Determination 2010/092

Refusal to issue a code compliance certificate for an 11-year-old house at 12 Albert Road, Nelson due to concerns over steel frames and a retaining wall

2.2.1 The steel frames consist of steel posts and beams installed to the garage and beneath the deck of the house, as shown in the sketch in Figure 1.

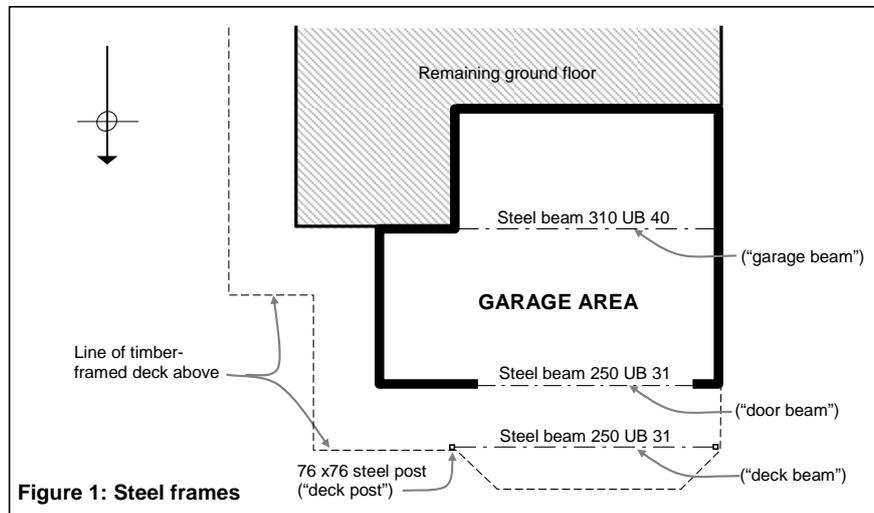
- stiffeners at each end of the beam as shown in the consent drawings
- fillet welds at the junctions of the posts with the beam
- at the west end, the post base was buried beneath asphalt
- at the east end the post was supported on a concrete pad that was 600mm x 400mm x 210mm deep, with a baseplate bolted into the concrete
- the painted steel had areas of light rust on the baseplate and the beam.

5.2.6 However, the expert was concerned about the concrete foundations to the deck posts, with one end hidden from view and the visible concrete pad at the other end only 210mm deep. The expert concluded that, while ‘the steel structure appears sound, the integrity of the concrete footing needs an opinion from an engineer’.

The deck support post foundations are inadequate and should be replaced with foundation pads of sufficient depth that they bear on the Port Hills gravels or firm clay. Excavations would need to be inspected and approved by a Chartered Professional Engineer.

- 6.1 Taking account of the expert's and the engineer's reports, I conclude that remedial work is necessary for the following areas:
- the foundations of the deck support posts, as described by the engineer in paragraph 5.5.2
 - the light corrosion apparent to some areas of the steelwork.
- 6.2 The authority's inspection records, the expert's report and the engineer's statements allow me to conclude that the remaining areas of the steel frames are likely to be adequate, despite the lack of engineering oversight commented on by the authority (refer paragraph 3.5). I am therefore able to conclude that satisfactory rectification of the areas outlined in paragraph 6.1 will result in the frames being brought into compliance with Clauses B1 and B2 (insofar as it applies to B1) of the Building Code.

- the deck post foundations do not comply with Clause B1 of the Building Code
- the steel frames do not comply with Clause B2 of the Building Code, insofar as it relates to Clause B1
